Local Grant Identification for EPOC TDD (baseline proposal amendment)

Andrea Garavaglia and Patrick Stupar
(Qualcomm)

Gate processing in CLT for local (TDD) grant

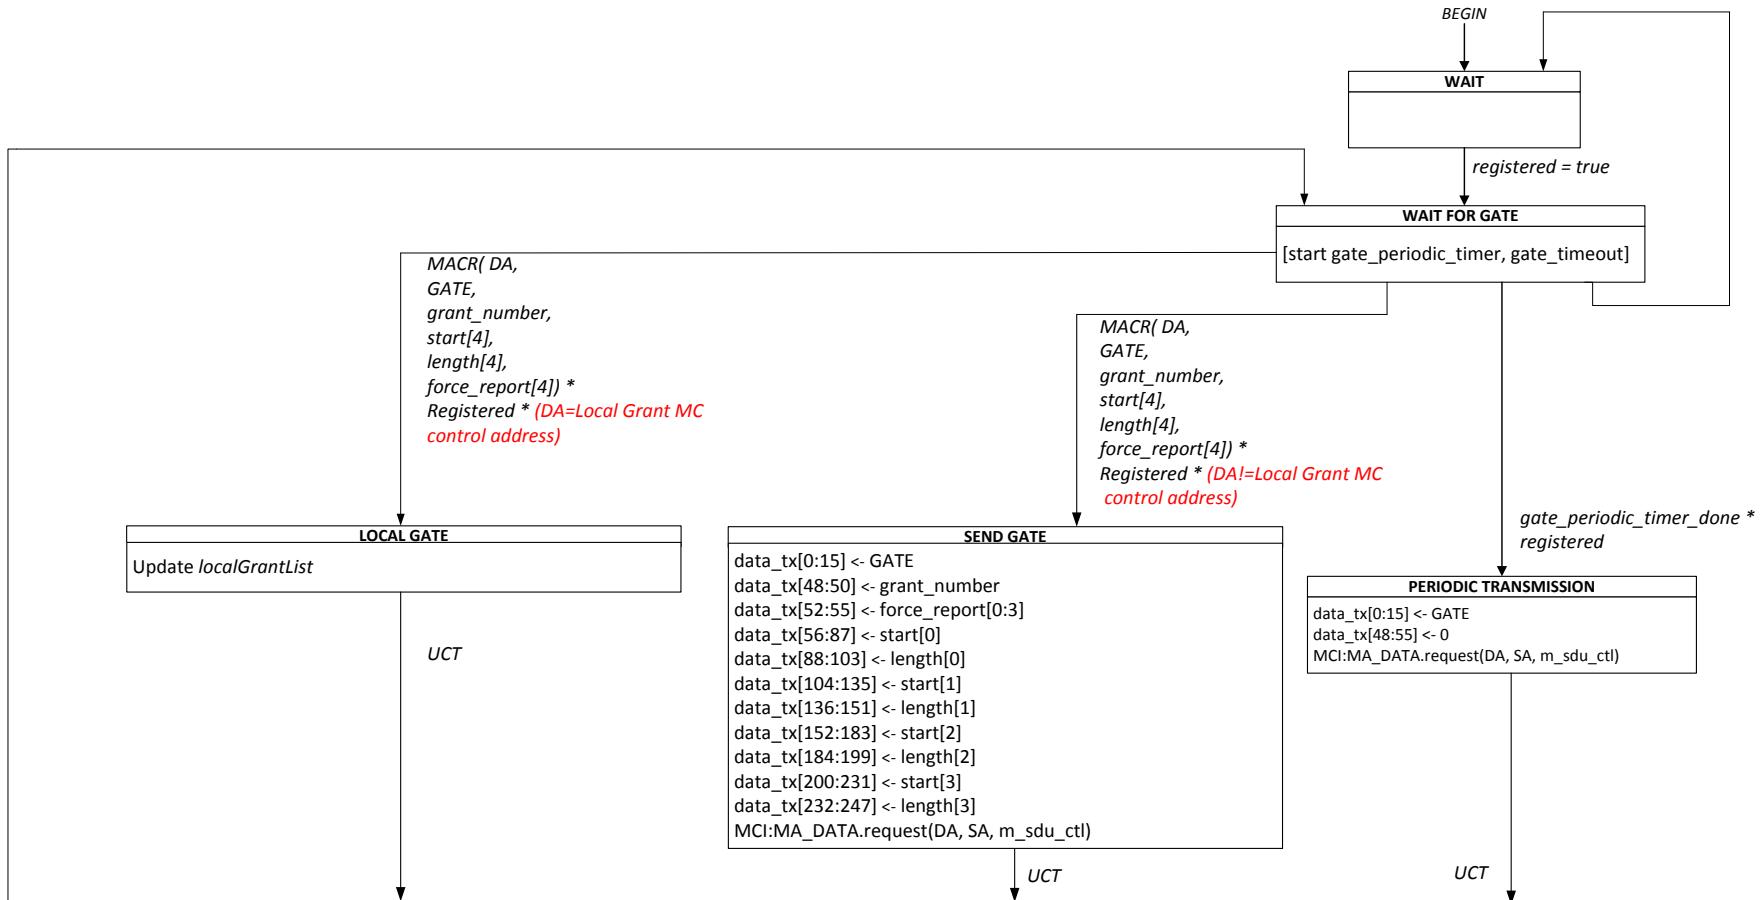
In the current design, the DA is used to identify a Local Grant from a CNU Grant (see red boxes above).

Comment: the Destination Address (DA) for non-discovery GATE in the *MA_CONTROL.request* primitive is defined in IEEE 802.3 Clause 77.3.3.5 as “Multicast MAC Control address as defined in Annex 31B”.

1. Definition of a new MAC control address for local grant
 - E.g. similar to the MAC control multicast address 01-80-C2-00-00-01.
2. Definition of a new primitive
 - Extend Gate *MA_CONTROL.request* primitive for local grant gating
